# Sandia Laboratories

subject: Errata for NUREG/CR-0779 - SAND78-2347 Fracture Toughness of PWR Component Supports, June, 1979.

FIG. 4.4 SHEAR PIN  
 (a) GEOMETRY,  
 (b) STRESS INTENSITY

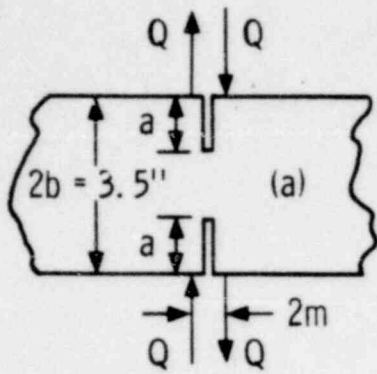
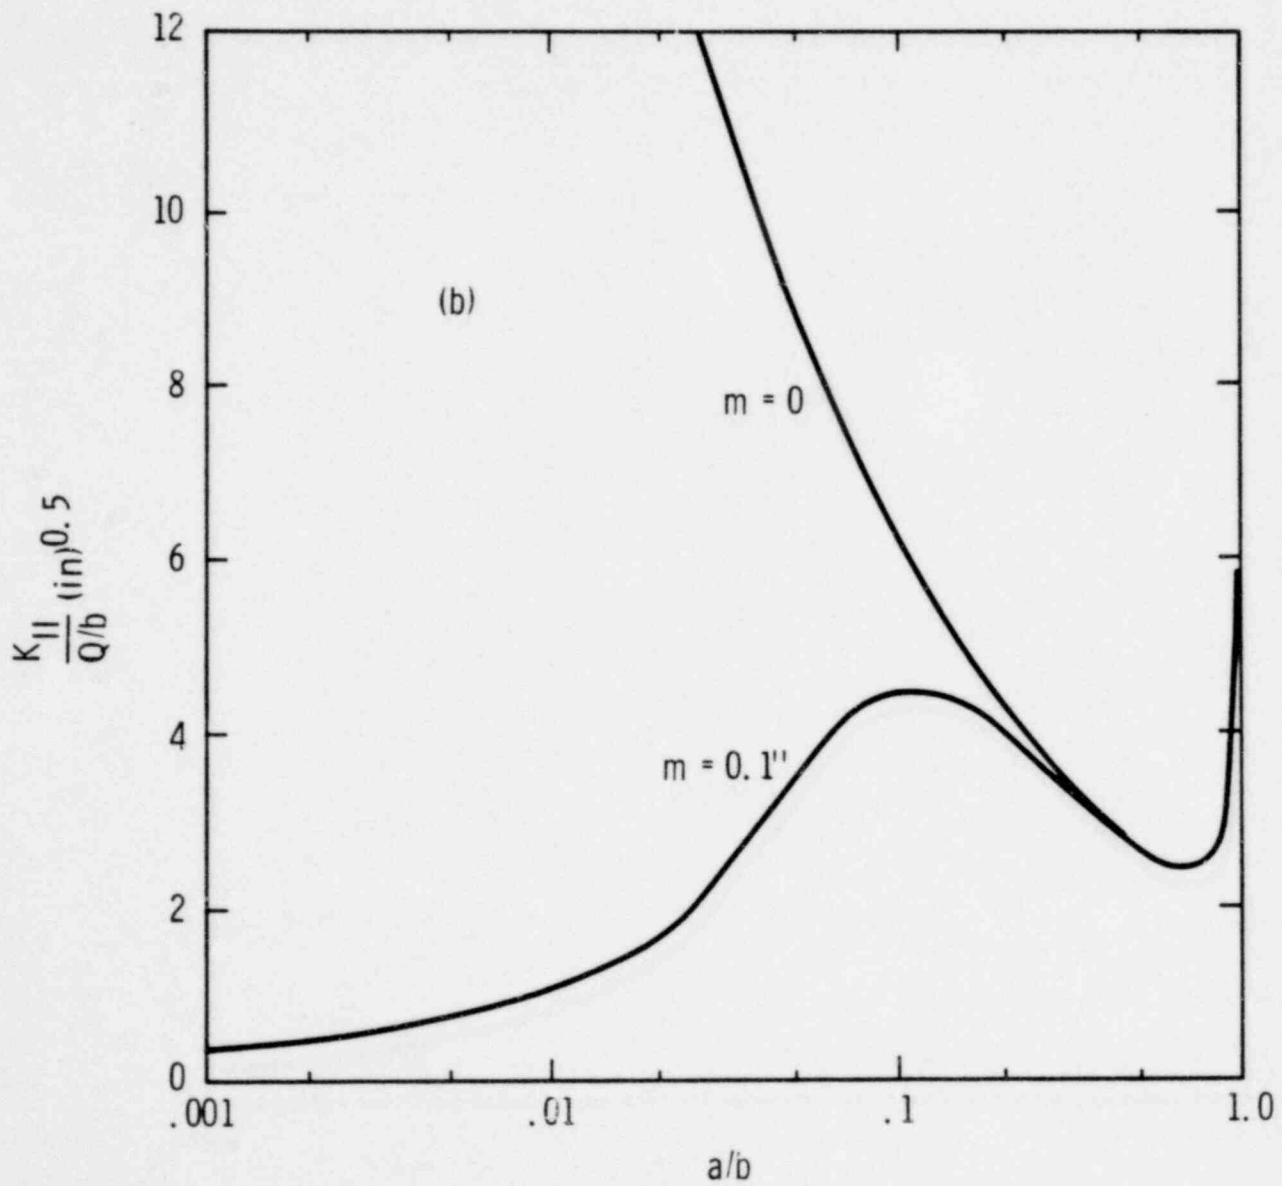
Also, the graph in Fig. 4.4 is incorrect; and as a result some modifications to Section 4.9.4 and Table 4.9 must be incorporated.

The corrected Fig. 4.4 (Page 69), section 4.9.4 (Page 58), and the appropriate part of Table 4.9 (Page 64) are appended. The corrected text materials are underscored where changes were made.
